TO: Homer Advisory Planning Commission
THROUGH: Rick Abboud, AICP, City Planner
DATE: 11/30/21
SUBJECT: Supplemental packet items

The supplemental packet contains a response to comments provided after the packet was initially distributed. This includes Mr. Griswold's email and response with a detailed review of the Comprehensive Plan analysis and a diagram that identifies the proposed fence layout and lighting plan.

From: Frank Griswold <fsgriz@alaska.net>
Sent: Monday, November 29, 2021 11:48 AM
To: Department Planning
Cc: Travis Brown; Melissa Jacobsen; Rick Abboud
Subject: Proposed CUP 21-08

1 **Responses to Griswold comments – Rick Abboud 11.30.21**

Fencing + lighting plan

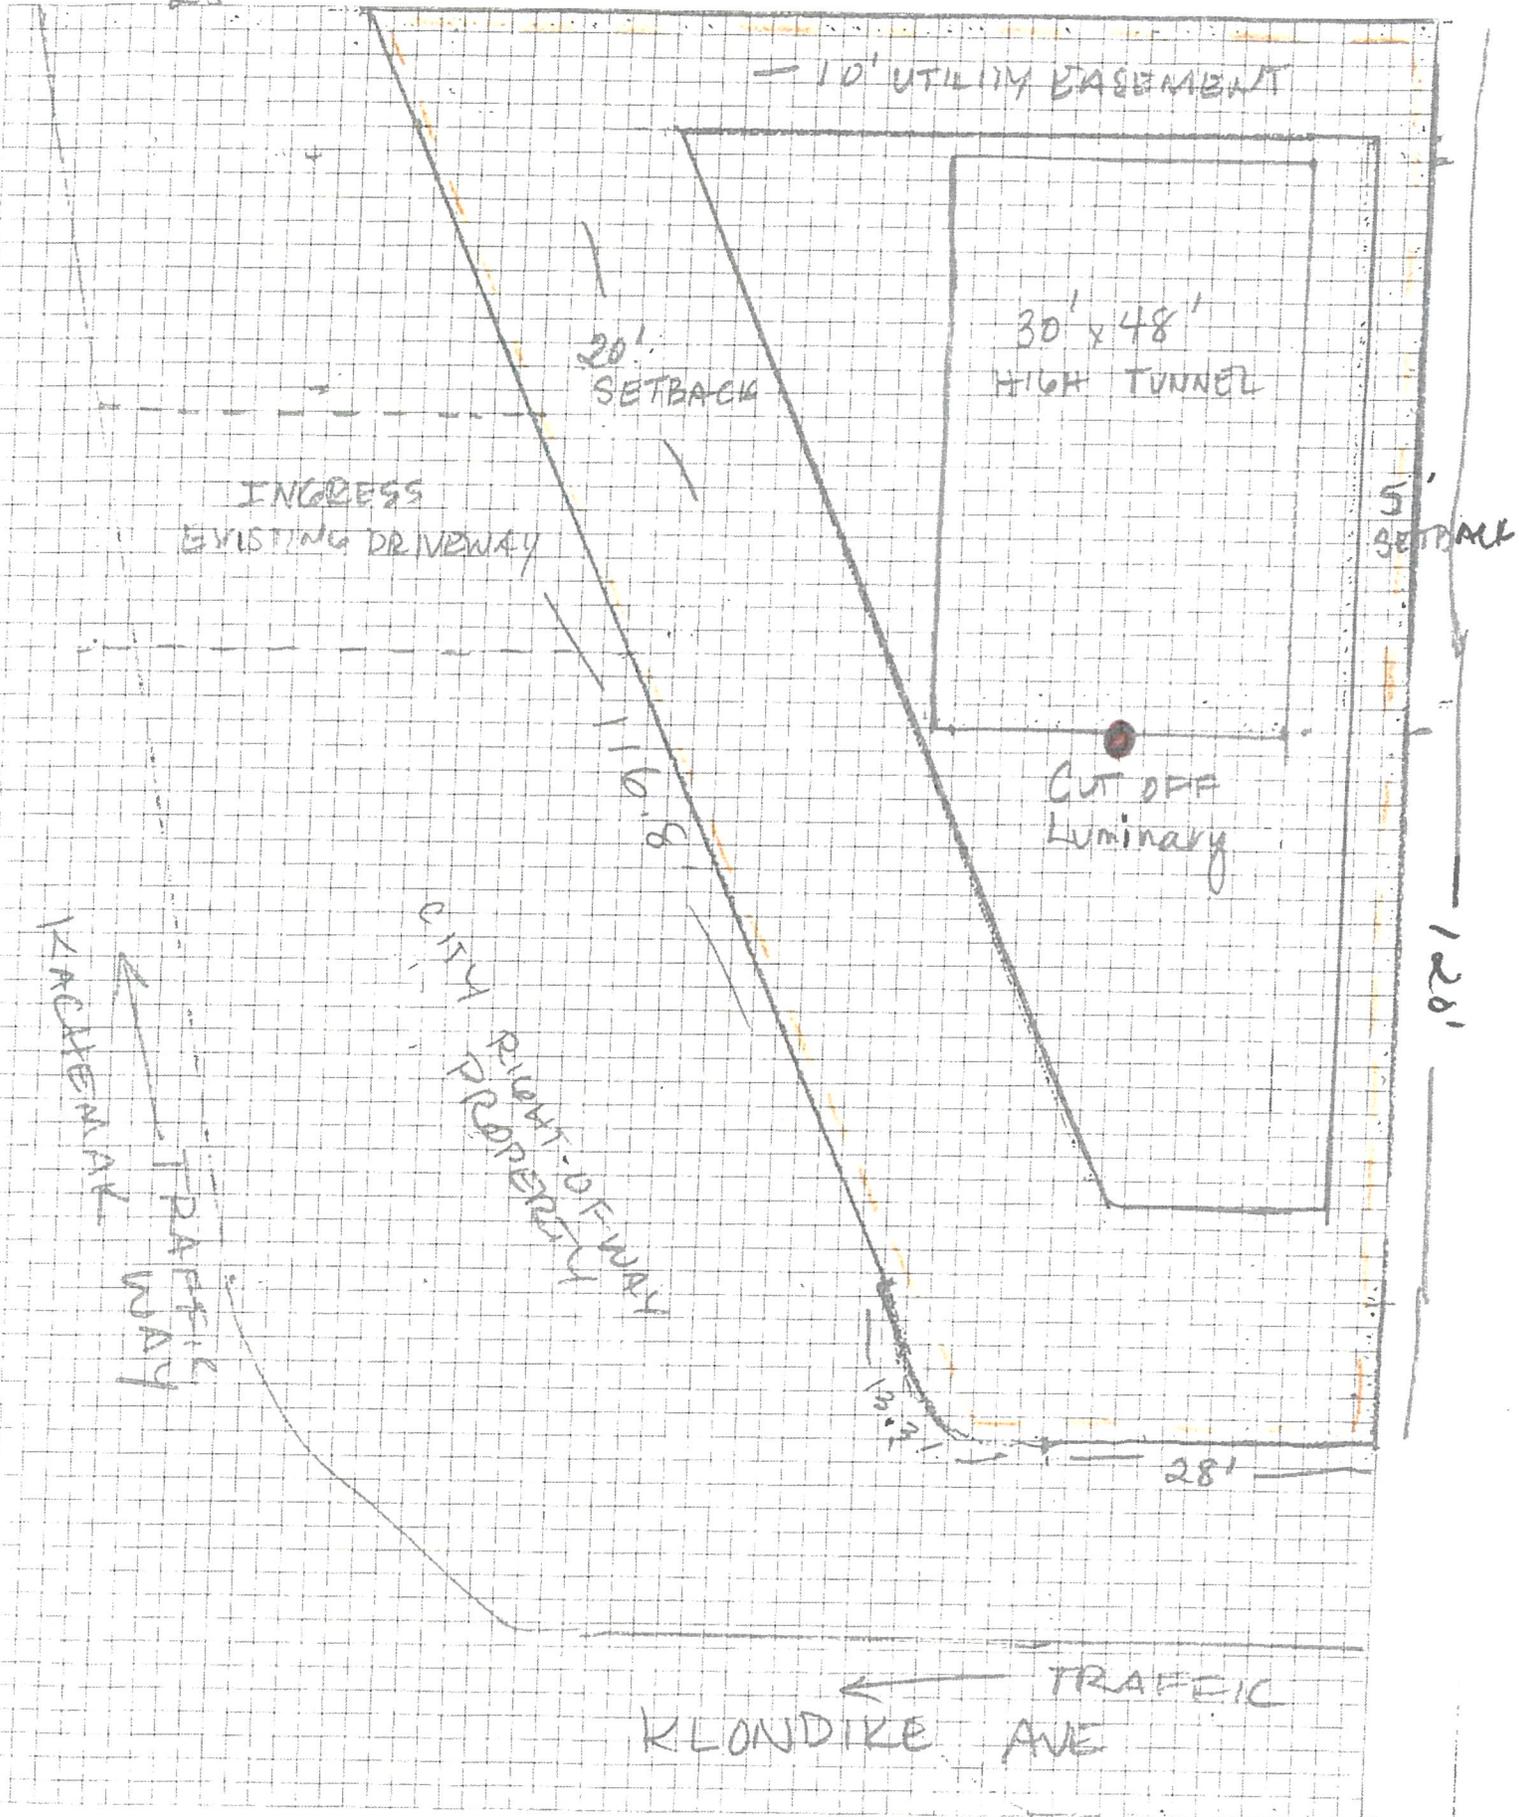
23
24 The Applicant states: “All students, staff and faculty will be parking in the university
25 parking lot that has 111 parking spots, and walking to the property.” ... “[F]encing will
26 keep anyone on the property from encroaching on the neighbors.” Examples of a moose
27 fence were included with the Application but no actual fencing is depicted on the Site
28 Plan. On August 17, 2021, I asked KBC Director Dr. Reid Brewer if the college had
29 any plans to install a fence along the east property line of the subject lot which abuts
30 my lot. On August 18, 2021 he replied: “Yes, we are planning on installing a fence this
31 fall.” To date, no fence has been installed. Fencing along the west property line should
32 also be required. All fencing should comply with the CDM and be designed so as to not
33 injure or trap moose, dogs, or other animals. To insure that all fencing is
34 properly placed, a professional survey of the subject lot should be

35 required as a condition for approval of CUP 21-08.

146 conditional use permits even if they are not otherwise deemed
147 applicable within the text of the CDM. The Commission does not
148 have the authority to ignore HCC 21.71.030(j) as if it were never
149 enacted. No outdoor lighting plan was submitted with the
150 Application. Outdoor lighting standards are set forth in HCC
151 21.59.030 so making down lit lighting the sole condition for CUP
152 21-08 would indicate that greenhouse use is no more
153 objectionable than any use permitted outright via HCC
154 21.18.020. But if this were the case, the duly elected Homer City
155 Council would likely have designated greenhouse use a permitted
156 use instead of a conditional use.

36
37 A fencing example is included and it is planned to incorporate a fence around the
38 entire lot. A supplemental depiction of the placement of fencing has been provided.

157
158 *An outdoor lighting plan has been included in the supplemental packet. It consists*
159 *of a cut-off luminaire placed above the south facing door. A complete review of*
160 *applicable elements of the CDM has been included.*
